Planning Commission Staff Report

Project Type: Sign Package

Meeting Date: October 26, 2016

Description: Monarch Center, Sign Package: A request for a Sign Package to establish sign

Figure 5: Lot A, North Building Elevation

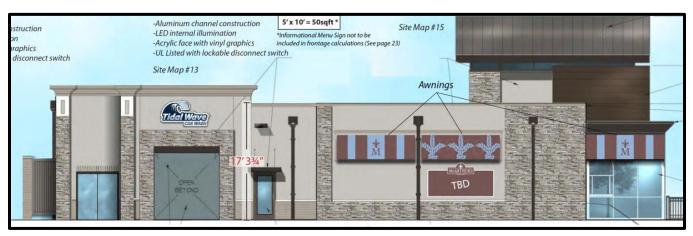
The applicant is also requesting a sign for the McArthur's Bakery tenant space. **The proposed sign is 8.9% of the tenant area façade**. The applicant notes that this sign is partially blocked from view by the gas pump island canopy. The north building elevation includes a menu board and awning signage for McArthur's Bakery as well as an attached wall sign for the Tidal Wave carwash. An identical Tidal Wave sign is also proposed on the south elevation. No signage is proposed on the east building elevation that faces inward to Lot C of Monarch Center which is slated for future development.

Figure 7: Lot A, Gas Pump Island Signage

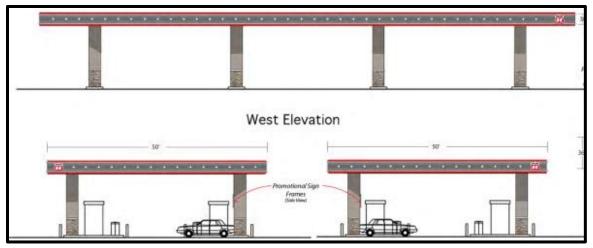
The applicant is also requesting to place three 6.25 square foot logo signs on three elevations of the gas pump island canopy. The UDC permits for one sign on any two elevations, with a maximum of 10 square feet in size for each sign.

Figure 8: Lot B, Wildhorse Dental Proposed Cabinet Sign

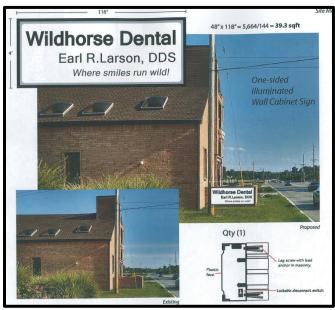
The only existing building within the Monarch Center development is the Wildhorse Dental building on Lot B. This building currently has two attached wall signs, with one sign located on the west façade and one sign located on the south façade. The applicant is proposing to maintain both existing signs and is requesting one additional attached wall sign, an illuminated cabinet sign, as shown below. Staff would note that the requested cabinet sign is neither similar in design or construction with the existing sign that is to remain nor to the other new signs proposed throughout the Monarch Center development. The illuminated cabinet sign would be placed on the small entry wall that is perpendicular to the west façade, as shown in the following excerpt from the Sign Package.

- 1. The proposed illuminated cabinet sign on Lot B, Wildhorse Dental is not of similar design or construction to the existing or proposed signs for the Monarch Center development. Staff recommends that the design of this sign be altered to correspond to either the existing Wildhorse Dental sign or the new signs proposed on Lot A.
- 2. Temporary advertising banners are requested for 20 cumulative weeks per year. Additionally, three of these 50 square foot signs are requested to be allowed at any given time. This is excessive for temporary sign allowances and does not conform to the surrounding developments which are not permitted to have temporary advertising signage. Staff recommends that language prohibiting "advertising signs, temporary signs, portable signs, and attention getting devices" be included in the Sign Package for Monarch Center.

Figure 13: Lots A & B, 6 sq. ft. Directional Signs

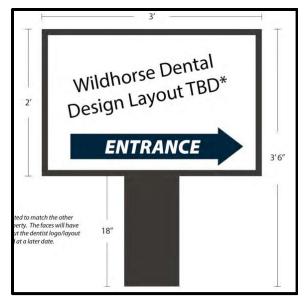
The applicant is proposing four new directional signs for the site. The requested outline area of the text and graphics for three of the requested signs is six square feet, which is less than the maximum allowed per the UDC. These three signs are 3'6" in height, and one is located just inside of the 145' building setback parallel to Long Road. Staff would note that this setback is specific to the building only, and a less restrictive 60' setback is in place for the gas canopy and the site specific ordinance excludes free standing project identification signs from the setback requirements.

Figure 14: Lot A, 12 sq. ft. Directional Sign

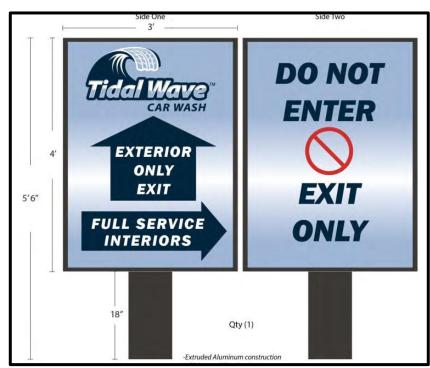
The fourth sign is proposed to be 12 square feet in outline area and 5'6" in height. This sign is located near the car wash tunnel exit and provides directions for vehicles based on the type of car wash purchased. Again, this sign is located just inside of the 60' building setback parallel to Edison Avenue.

Figure 16: Menu/Order Board Signs (6)

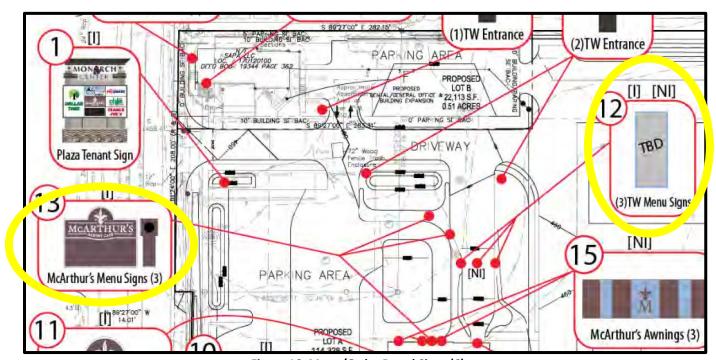
The applicant is requesting menu/order board signs in conjunction with the drive-thru restaurant and car wash. These signs are outlined in yellow below. The UDC does not address order board signage for car washes, and menu board signs for drive-thru restaurants are limited to 32 square feet in outline area, with one freestanding and one attached wall sign permitted. It is typical for a second "pre-order" sign to be permitted as "incidental signage". The Sign Package request includes two, 50 square foot freestanding menu board signs for the drive-thru restaurant. Additionally, one 50 square foot attached wall sign is requested, as shown on page 5 of this report. Although Staff takes no issue with the number of menu board signs, the cumulative size of the freestanding signs seems excessive and Staff recommends reducing the size of the second "pre-order" sign to the base code allowance of 32 square feet in outline area.

Further, the applicant is requesting two 26.7 square foot car wash order board signs and one 12 square foot car wash order board sign. As the drive-thru is two lanes in width, the signage is spread across the lanes and Staff does not take exception to the size, number, or location of these signs.

- 3. Two freestanding drive-thru menu board signs at 50 square feet are requested. This seems excessive and Staff recommends that one 50 square foot sign be approved, with the second sign being reduced to 32 square feet (or smaller) so it is "incidental" in nature. This is consistent with other drive-thru restaurants throughout Chesterfield Valley.
- 4. Consideration should be given to the allowance of LED gas grade signage.
- 5. Consideration should be given to the calculation method of the attached wall signs on the primary façade of the Edison Express building, which excludes dead space from the overall percentage of sign coverage being requested.
